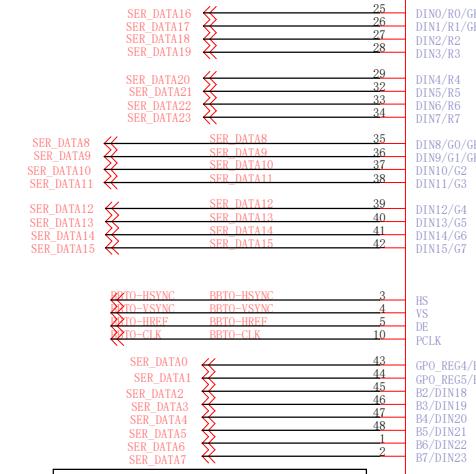
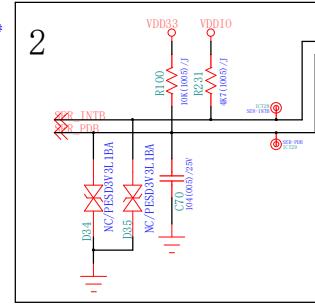
1 请确认此两处供电，均采用3.3V供电是否可行？  
Please confirm if we can use the same power of 3.3V?

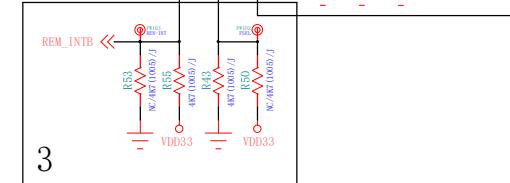
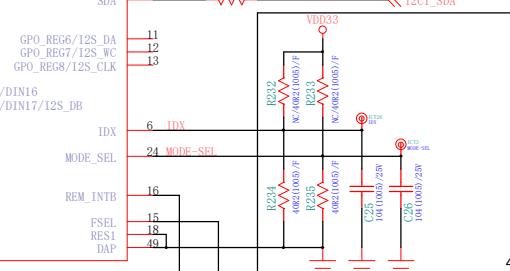
2 请确认此处电阻电容参数是否正确？  
Please confirm if the parameters of capacitors are OK?

替换成921；同轴输出；

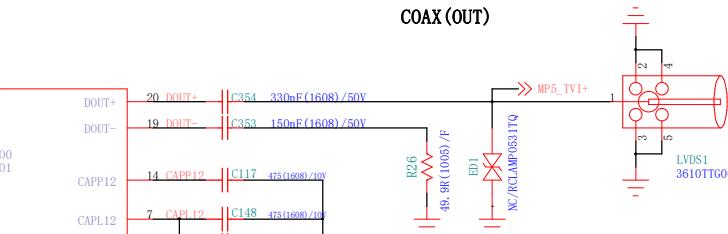
3 请确认此处电阻上下拉参数是否正确？  
Please confirm if the pull-up and pull-down resistors are OK?
